RE: M1973007SG, TR-11 Adequacy Review #1 - Holcim Response

Holcim has completed our response to your Adequacy Review #1 for TR-11 at the Daniels Sand Pit 2 Facility. The responses to your questions are in order below. Please let us know if you have any questions. We look forward to the DRMS's review and approval of this Technical Revision.

<p>Construction Drawings Daniels Sand Wash Fines Pond Embankment Dam Raise El Paso County, Colorado</p>	<p>GEI Consultants Project 2400434 Denver, Colorado</p>	<p>EMBANKMENT DAM SECTION AND DETAILS November 2024 Fig. 6</p>
---	---	--

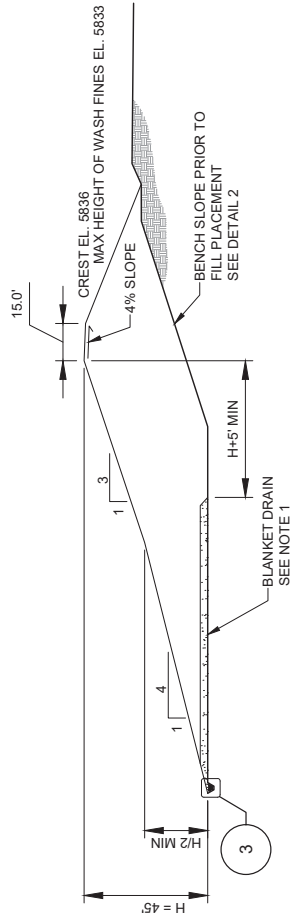
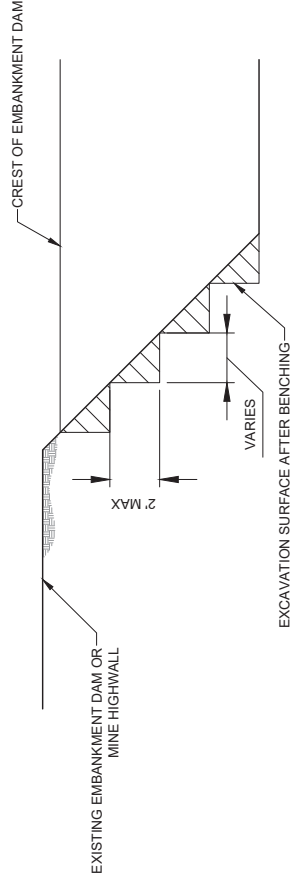
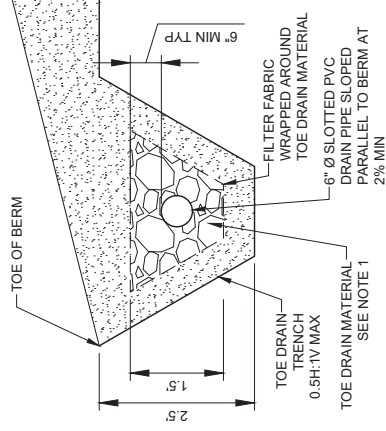
5. **DRMS Comment:** Page 2 of the Dam Raise Study states that the current height of the embankment is 22.5 feet. Page 1 states that the proposed change is a 22.5 foot raise to the embankment. Is the Division correct in interpreting this to mean that the proposed dam raise would create an embankment with a final height of 45 feet? Please also ensure that all figures included in the Dam Raise Study, specifically the cross sections on Figure 6 match this maximum embankment height.

Yes, the Division's interpretation is correct in that the proposed new final embankment height would be 45 ft. Please see the updated Figure 6, attached.
